STATE OF MAINE
DEPARTMENT OF TRANSPORTATION
16 STATE HOUSE STATION
AUGUSTA, MAINE 04333-0016

July 17, 2025
Subject: Bridge Replacement
WIN: 025161.00
Location: **Cumberland**
Amendment No. 4

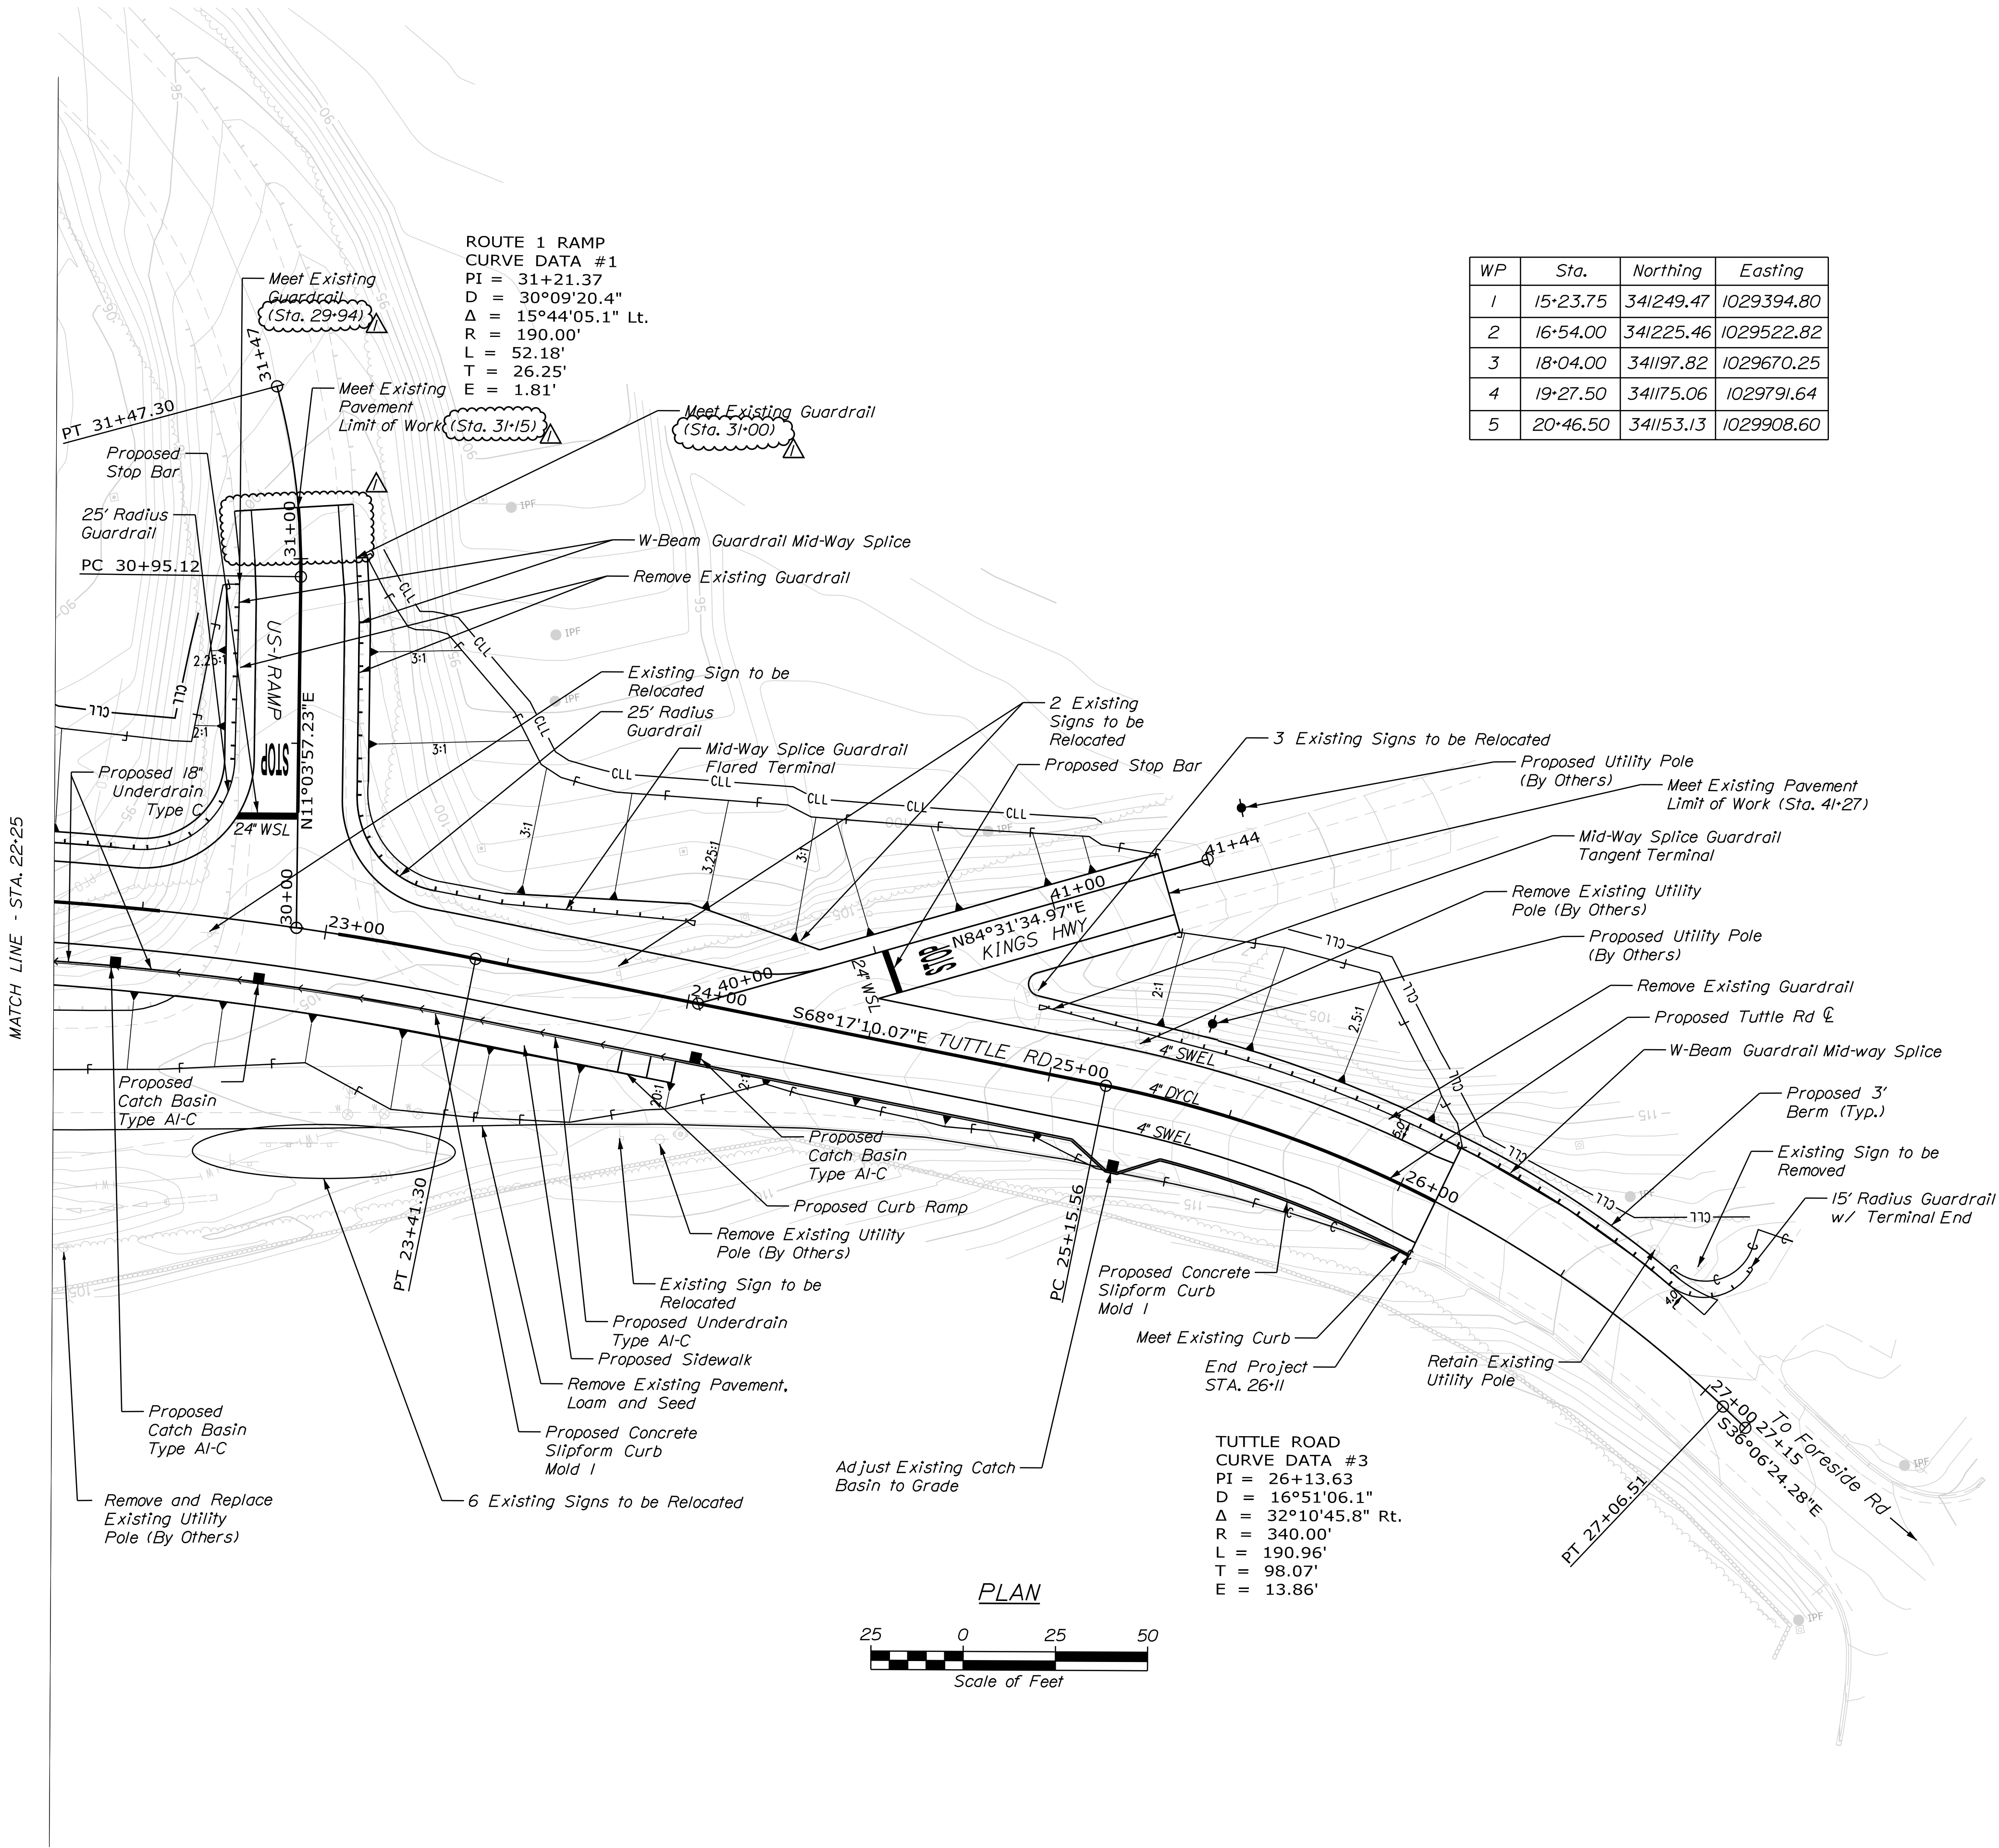
REMOVE Sheet Number 2 of 88, ESTIMATED QUANTITIES dated 6/30/2025 and **REPLACE** with the attached Sheet Number 2 of 88, ESTIMATED QUANTITIES dated 7/16/2025.

Question: Can you confirm the quantities of Hot Mix Asphalt, specifically, but not limited to 403.2131 12.5mm Polymer Modified HMA Base? The item quantity seems to be significantly lower than the plans and specs indicate.

Response: Please see the updated quantities on Sheet 2 and in the Proposal Schedule of Items.

SHEET NUMBER
43
OF 88

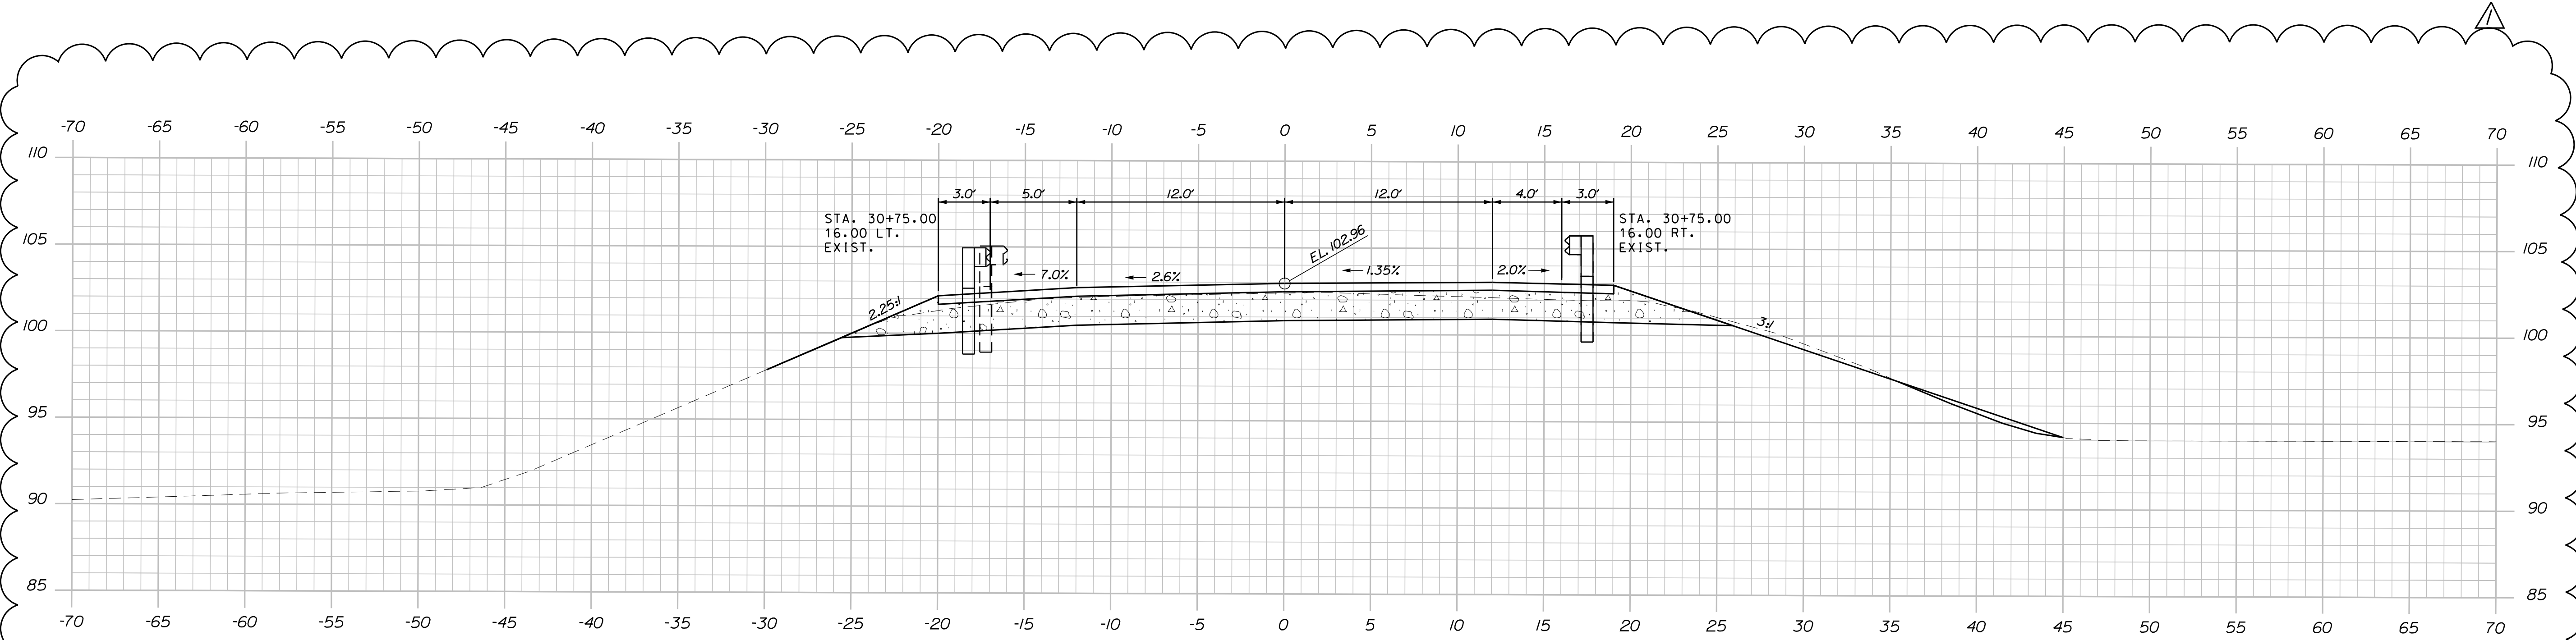
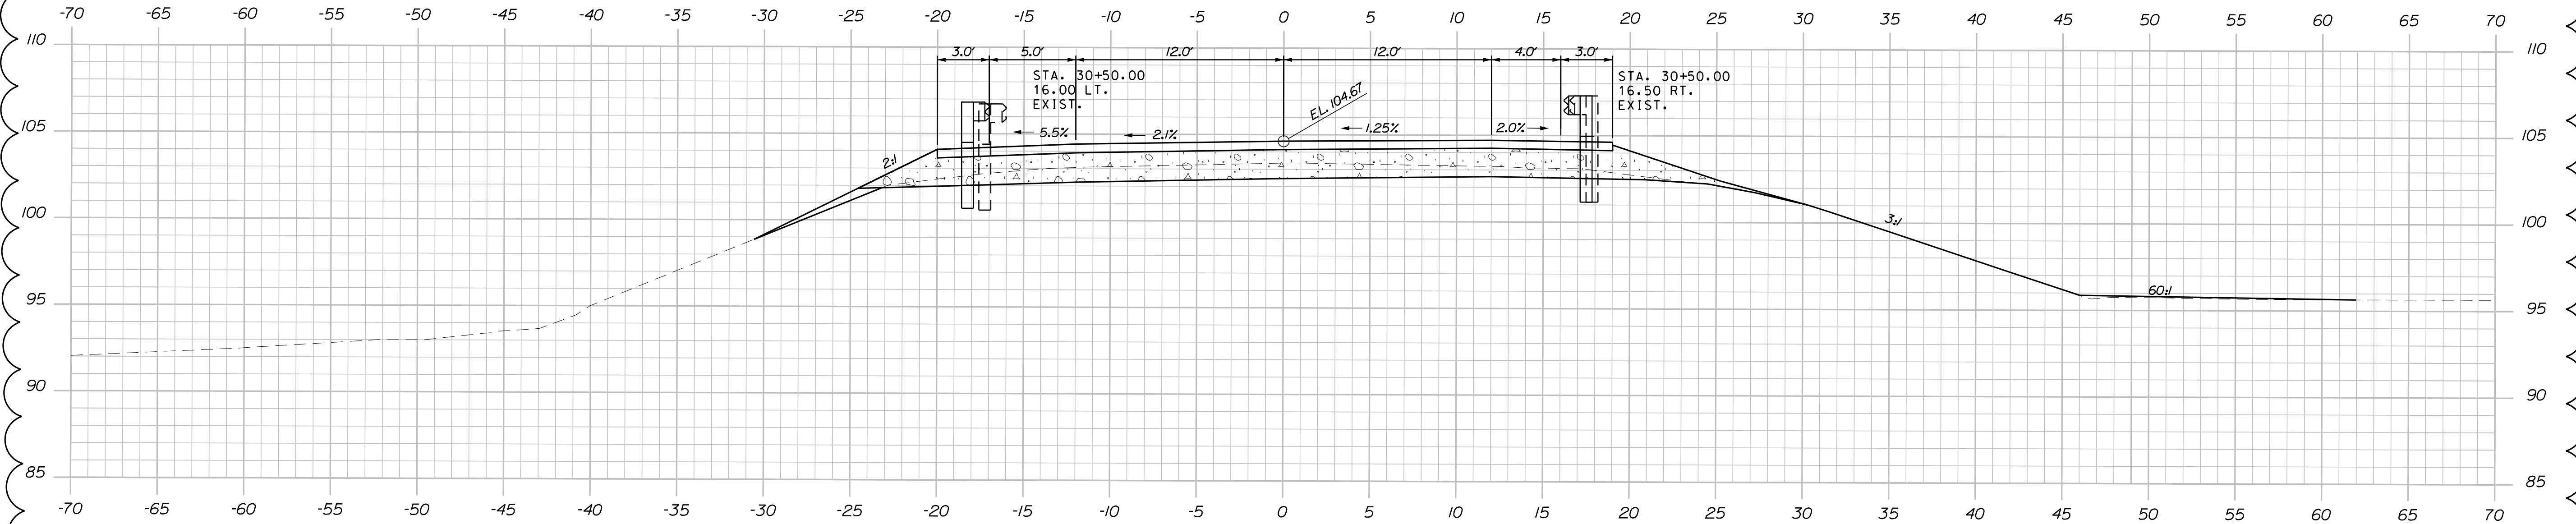
REMOVE Sheet Number 43 of 88, US ROUTE 1 RAMP CROSS SECTIONS (1 OF 2) dated 5/25/2025 and **REPLACE** with the attached Sheet Number 43 of 88, US ROUTE 1 RAMP CROSS SECTIONS (1 OF 2) dated 7/16/2025.

Question: Please clarify all limits of the mill and fills on I-295, Route 1 Ramp, and any other location mill and fills are called out in the specs. Thank you.

Response: Please see the response to the first question in this amendment. Mill and overlay limits to transition on Tuttle Road and the Route 1 Ramp are shown on the plans, profile, and cross sections.

30+75.00
STA 30+70
END FULL DEPTH RECONSTRUCTION
BEGIN TRANSITION

30+50.00
FULL DEPTH RECONSTRUCTION

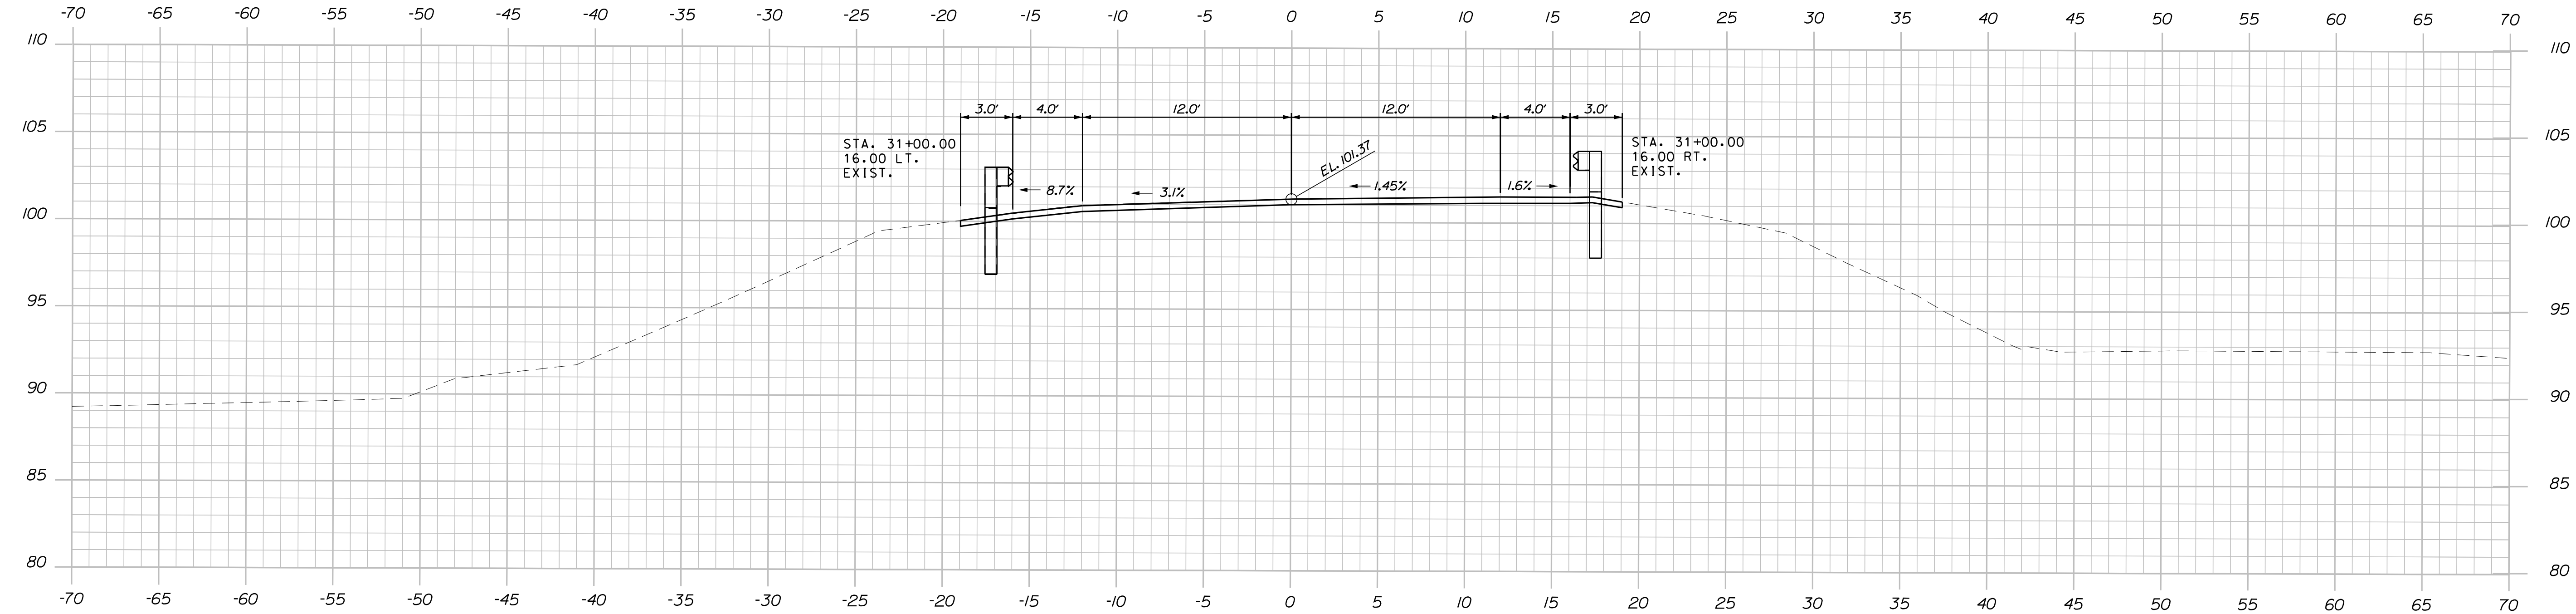
REMOVE Sheet Number 44 of 88, US ROUTE 1 RAMP CROSS SECTIONS (2 OF 2) dated 5/25/2025 and **REPLACE** with the attached Sheet Number 44 of 88, US ROUTE 1 RAMP CROSS SECTIONS (2 OF 2) dated 7/16/2025.

31+00.00
STA 30+95
END TRANSITION
BEGIN 3" MILL & OVERLAY
